TRI-PARTY AGREEMENT

Change Notice Number TPA-CN- 0775	TPA CHANGE NOTICE FORM	Date: 7/16/2019
Document Number, Title, and Revision: DOE/RL-2000-56, Waste Management Plan for the 300-FF-5 Operable Unit, Rev. 2		Date Document Last Issued: September 2015
Approved Change Notices Against this Document: TPA-CN-683, TPA-CN-0755, TPA-CN-0819, TPA-CN-0852		
Originator: S.M. Sexton		Phone: 373-2285

Addition of the consolidated groundwater solid waste complex located in the Central Plateau to approved IDW storage locations. Added text to clarify, as well as figures showing the location of the 6265A Building for identification.

Figure 3. The 6265A Building Location.

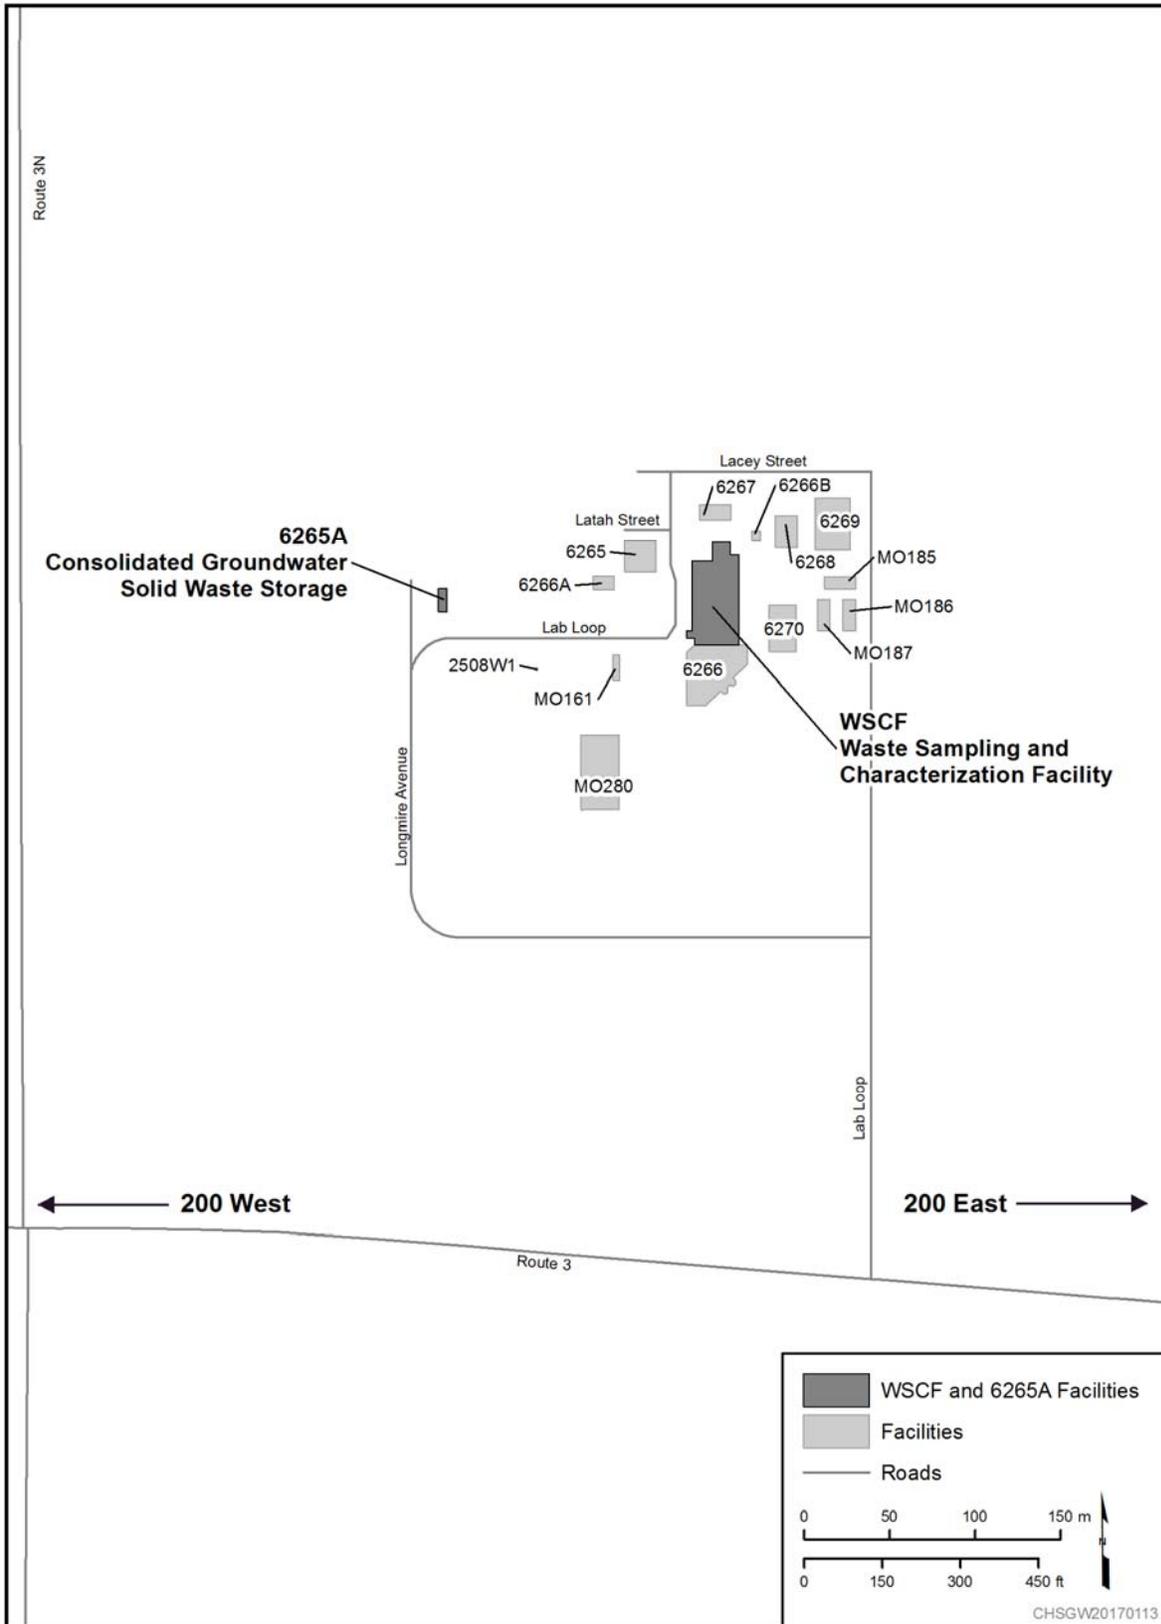
Added new figures to DOE/RL-2000-56 to show the location of the new consolidated waste complex at the 6265A Building located in the Central Plateau, and to show the outside of the building for identification.
